## SURFACE MINING INSPECTION REPORT

Notes from 2021 Annual SMARA Inspection Conducted on 9-17-2021

Lehigh Quarry is a vested hard rock quarry which has been in operation since approximately 1903. The operation primarily harvests limestone for the production of cement but has also produced greenstone aggregate in the past. Over time the quarrying operation has expanded, and now encompasses 546 acres of disturbed area. The site also includes a cement plant operating under a Use Permit and located outside of the Reclamation Plan area. The current Reclamation Plan was approved in 2012 as an amendment to the 1985 Reclamation Plan.

**PHOTO #20** – Check dam on the WMSA road

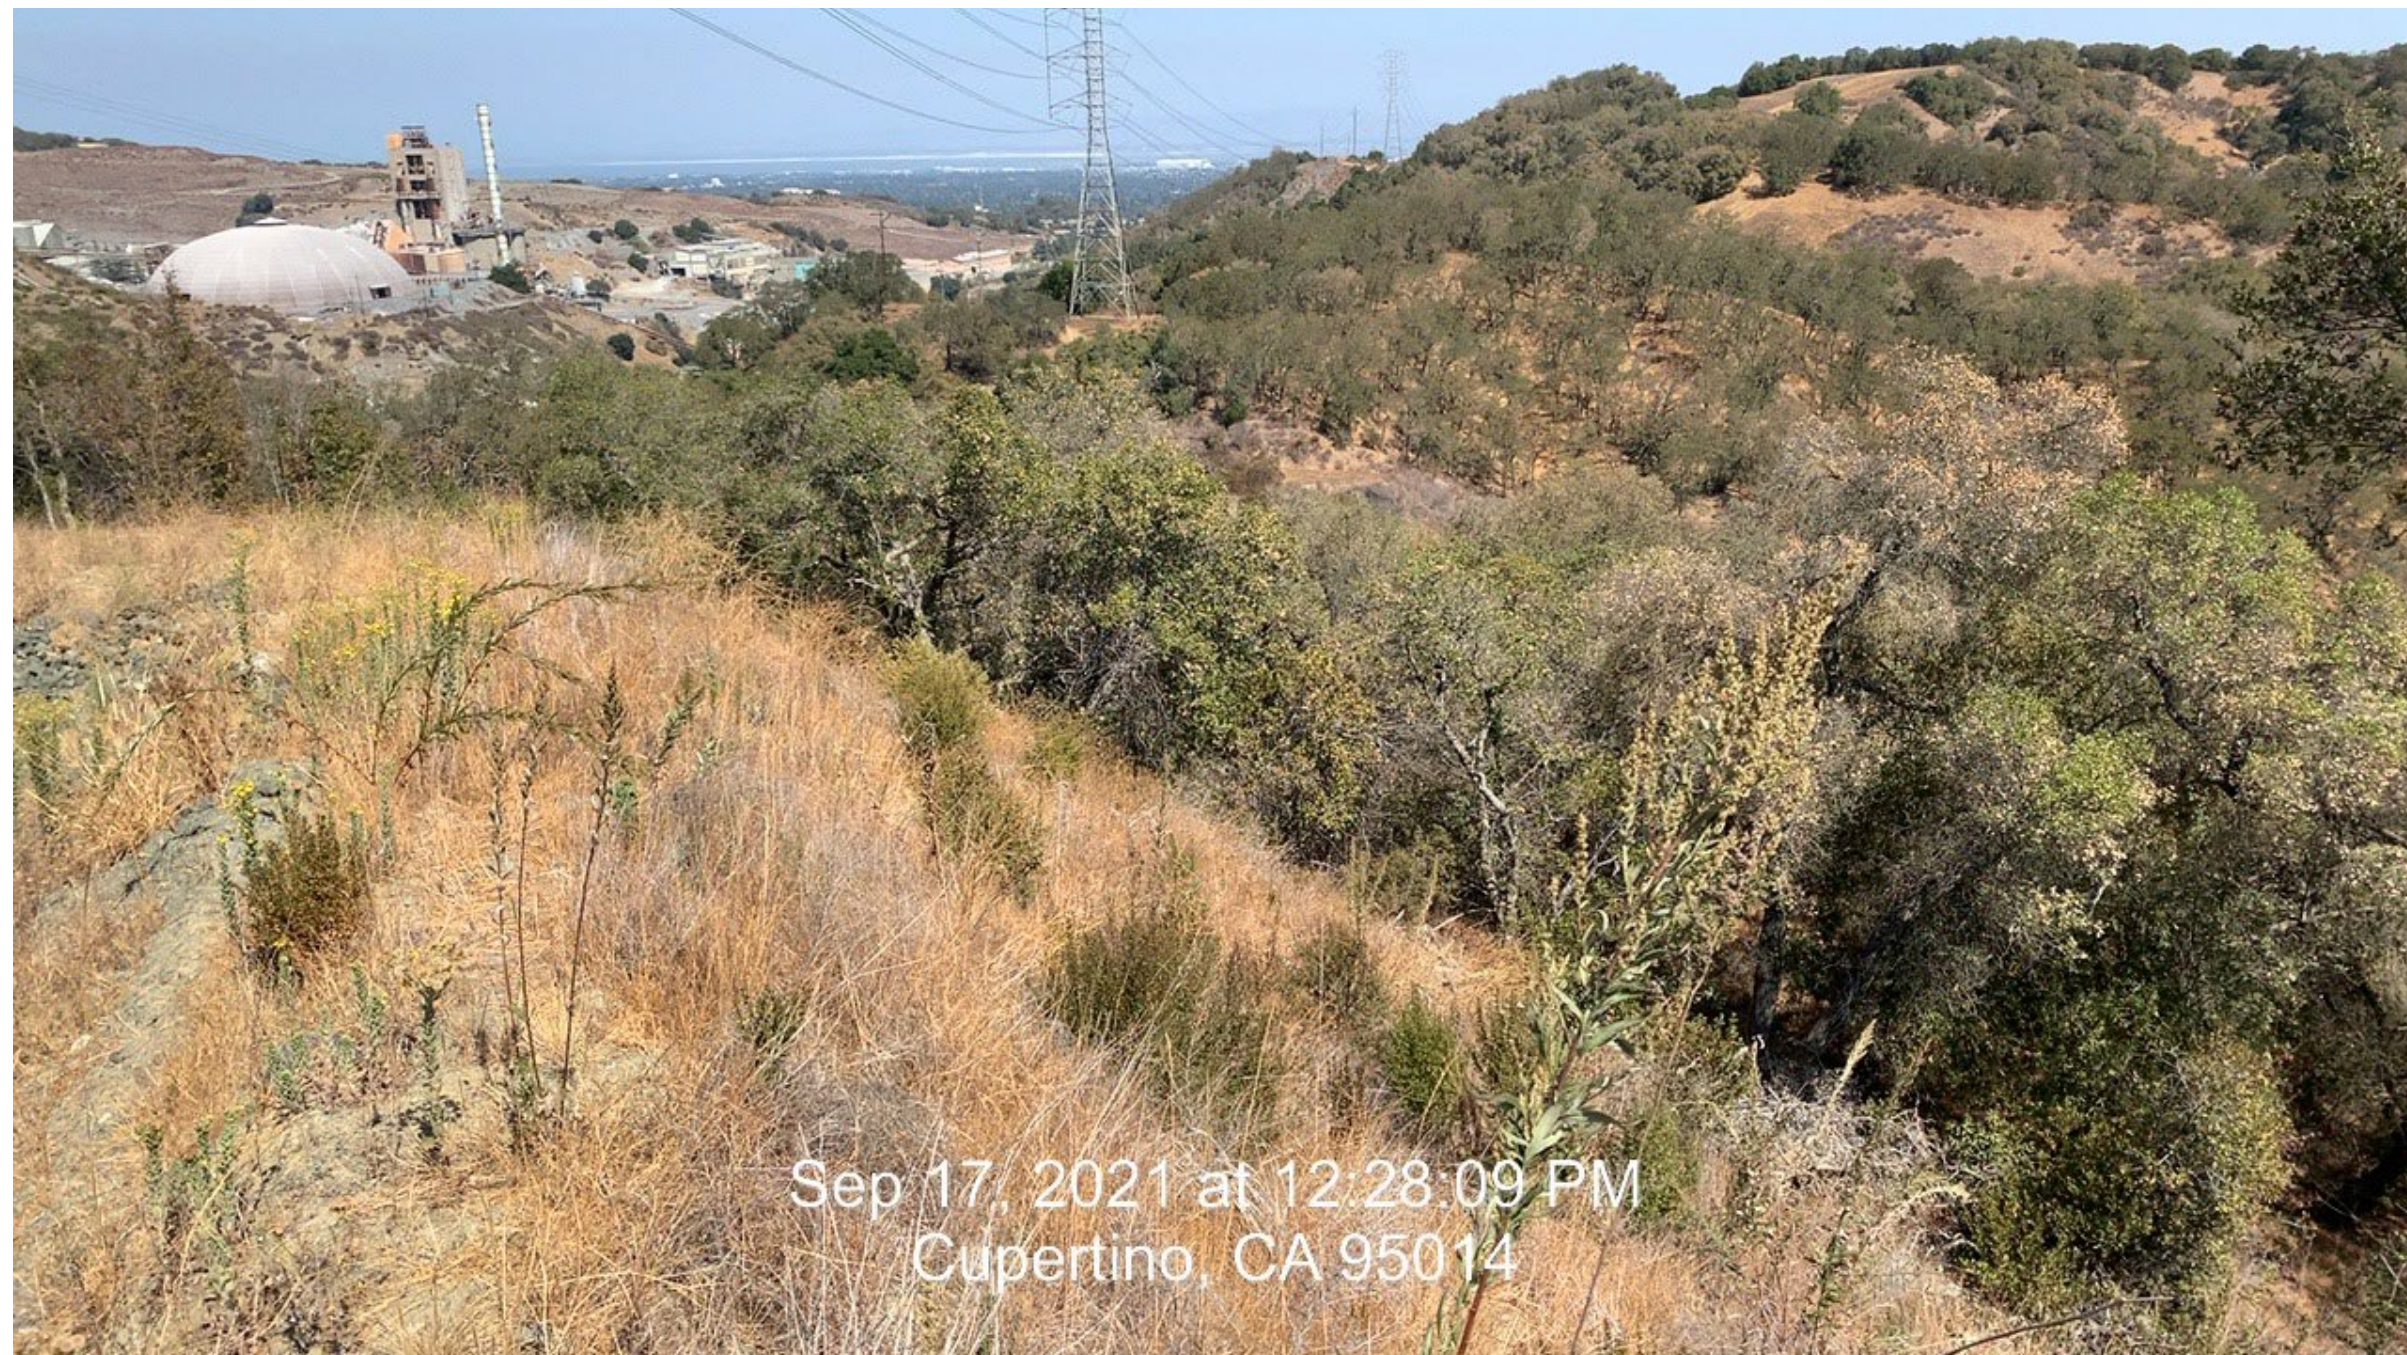
Runoff and drainage are controlled on-site by various methods including check dams installed on internal access roads. [See **Photo #20** for example check dam.] Check dams are required to be made of non-limestone rock in order to prevent selenium contamination. Erosion control measures are typically installed before the rainy season and are inspected during winterization inspections. As noted above, the County of Santa Clara issued a Notice of Violation related to inadequate erosion control measures which resulted in a discharge of sediment into Permanente Creek. Since then, the operator made numerous improvements to erosion control BMPs, and created a lined sediment basin to prevent any more sediment or loose rock from entering the Permanente Creek channel. See the Violations Section below for additional information.

**Photo #29 – Shallow slumps in fill material that was added to EMSA beginning in September or October of 2017; slumps have been re-graded by the operator**  
**(Ground photo not taken in 2021; aerial photos from Google Earth)**

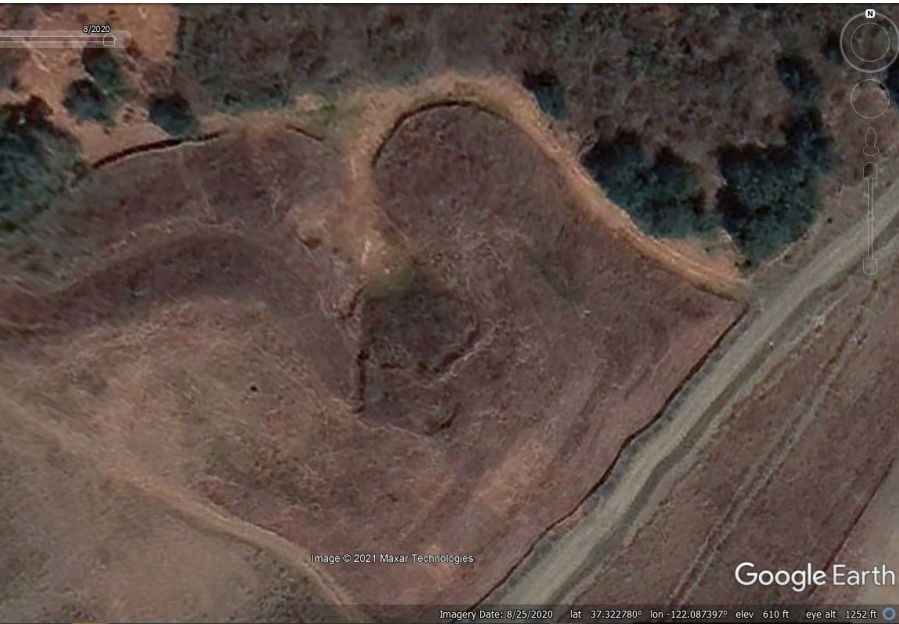
During the annual inspection, County inspectors observed an area in which recent grading had created a level pad adjacent to the modified utility road south of the Rock Plant. The fill slopes were covered with jute netting which had not yet been hydroseeded. [See **Photos 28A and 28B.**] In addition, County inspectors saw a localized area of shallow slumping of slopes on the northern side of fill placed in 2017 on top of the EMSA. [See **Photo 29.**]
